Subject: **Klondyke Storage Reservoir – response to Environment Canterbury s92 information request**

Water Quality of the Klondyke Storage Pond (informal information request)

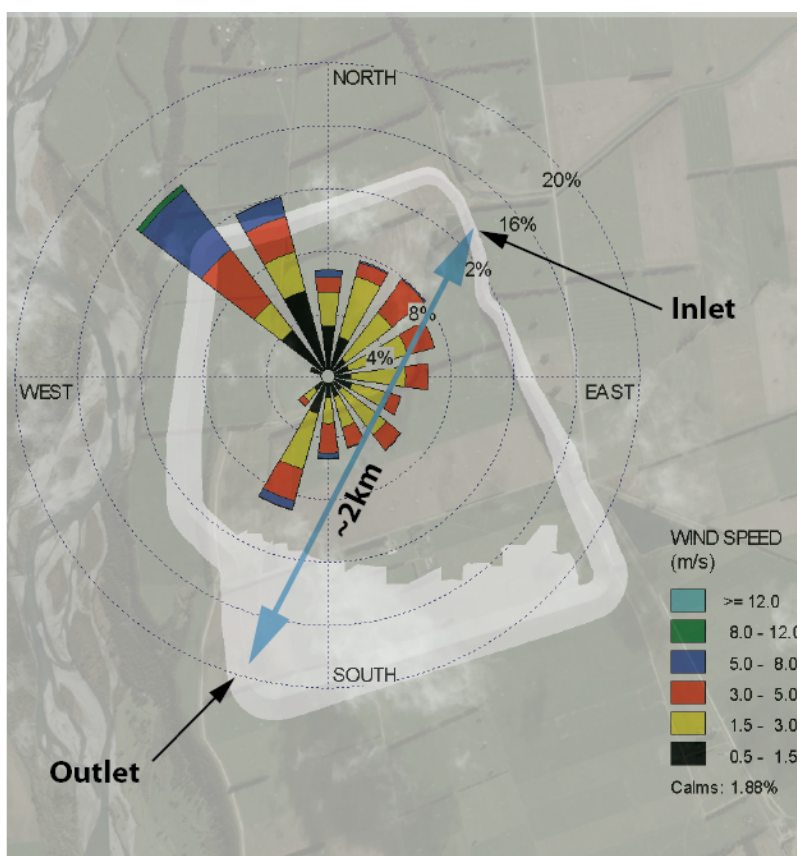
“During periods of time when the inflow/outflow appear to match closely during the irrigation season, there is very little change in the reservoir volume. It is during these periods of time that it is important that the water does not pass directly from the inflow to the outflow such as by surface water sheet flow. Could you please address this risk and propose potential mitigation measures.”

Second, the prevailing wind direction, and strongest winds, are from the northwest quarter (winds are likely to be channelled down the Rangitata River Valley) and so are more or less at right angles to the direction of water flow if water sheeting was to occur (Figure 1). Therefore wind direction, frequency and strength are all likely to act to counter any potential direct routing of surface water and act to mix water across the reservoir.
